REF: 4 Gainsborough road Richmond TW9 2EA

Design Process, Appearance & Access

Pre Application response: 24/P0213/PREAPP

LOCATION: 4 GAINSBOROUGH ROAD, RICHMOND, TW9 2EA
PROPOSAL: GROUND FLOOR REAR EXTENSION, SIDE EXTENSION ON FIRST FLOOR AND DORMER EXTENSION ON ROOF

First floor side extension

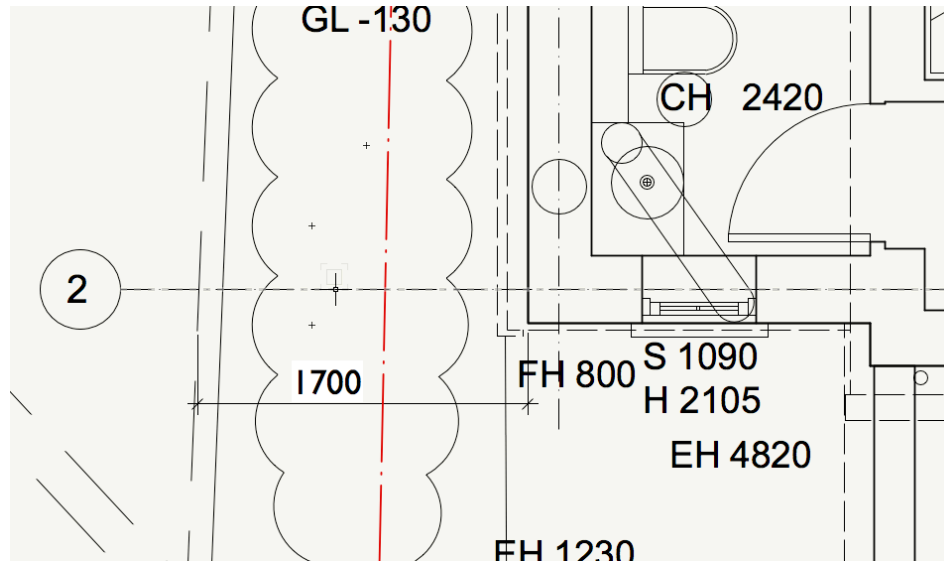
At first floor, the proposals seek to extend over an existing single storey side extension.

- *The proposal would have a height that matches the existing ridge, and would be set in line with the front elevation in order to integrate with the existing house. Whilst it is acknowledged the application site isn't part of a particularly uniform terrace owing to its shape, it is considered that this approach is acceptable in the context.*
- *The proposed extension would be less than half the width of the existing dwelling and would therefore be in compliance with SPD guidance in this regard.*
- *However it would be sited just ~0.5m from the side boundary, and would therefore fail to comply with the required 1m separation from the boundary.*
- *The proposed first floor side extension would therefore need to be reduced in width to increase the separation to the side boundary and prevent a terracing effect which would be harmful to the character of the area.*

- *The proposed first floor side extension fails to comply with the SPD guidance and should be set in from the side boundary.*

The proposed first floor side extension is proposed to sit on the existing ground floor

Currently there's a distance of 1.7 meters between the two buildings

So the existing ground floor is roughly 850mm from the boundary line

We could in-set the first floor by 150mm (6inches) to comply with the one metre guidance but we think it will look better to keep the first floor side extension in line with the ground floor

So we would like to suggest that although the proposed works do not comply with the one metre boundary of set, we are only 6 inches away from complying
